Technical Service Information

THM 4L60 AND 4L60-E PREMATURE 3-4 CLUTCH FAILURE

Figure 1

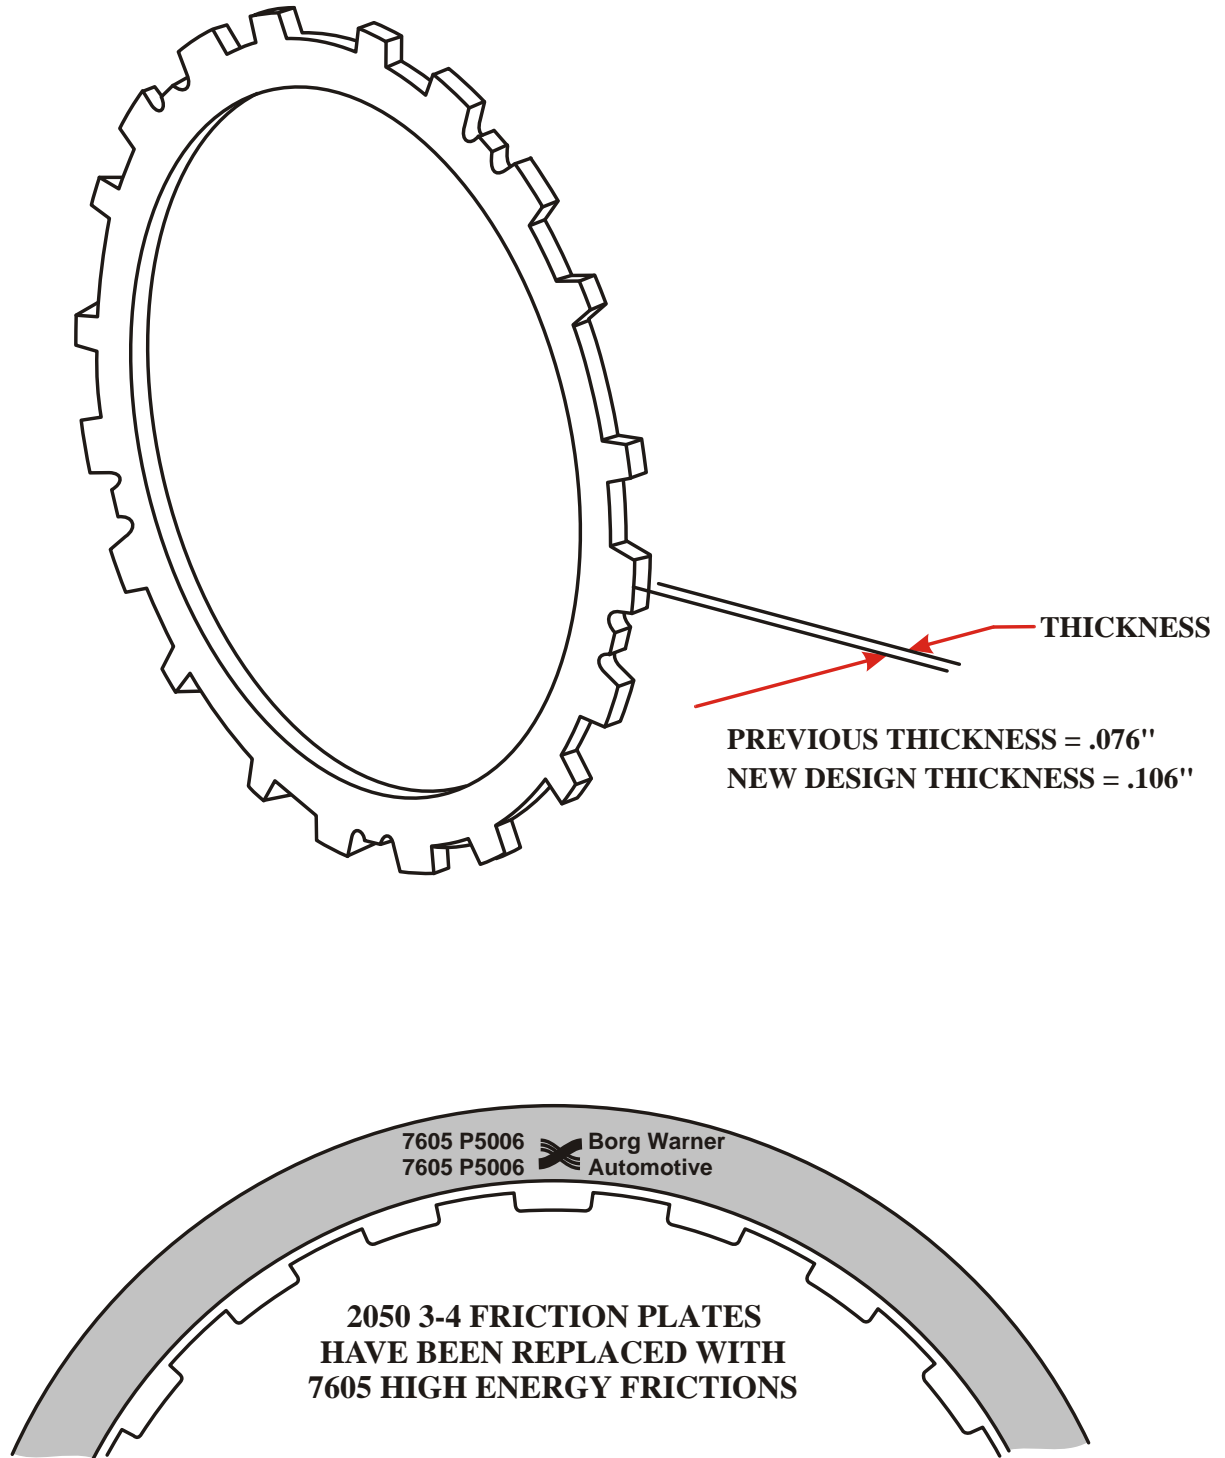
1. New design 3-4 Apply Ring with shorter legs.
2. New design one piece 3-4 Apply Plate.
3. New Design .106" thick 3-4 Steel Plates, 5 required (See Figure 1).
4. New design high energy 3-4 Friction Plates, 6 required (See Figure 1).
5. New design 3-4 Selective Backing Plate, as they are thinner.
6. Re-install the 3-4 Load Release Springs in the late design stack-up (See Figure 2).
7. Ensure that you have .050"-.070" clutch clearance.

The 2050 high energy friction plates normally associated with the above kit have been replaced with the 7605 high energy friction plates for increased durability. Refer to Figure 1. The 2050 high energy friction plates have been discontinued.

Figure 2

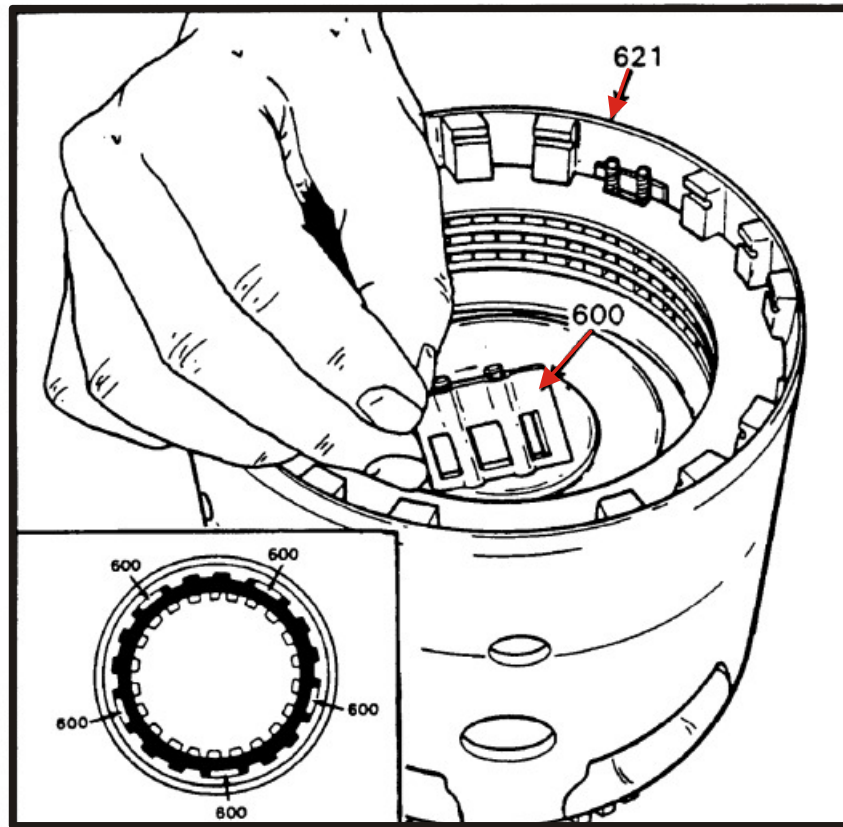
RE-USE THE 3-4 LOAD RELEASE SPRINGS IN THE NEW DESIGN CLUTCH PACK ONLY

Re-install the 3-4 load release springs when you are using the .106" thick steel plates, 7605 high energy lined plates, new design 3-4 apply ring, new design one piece apply plate and new design backing plate.
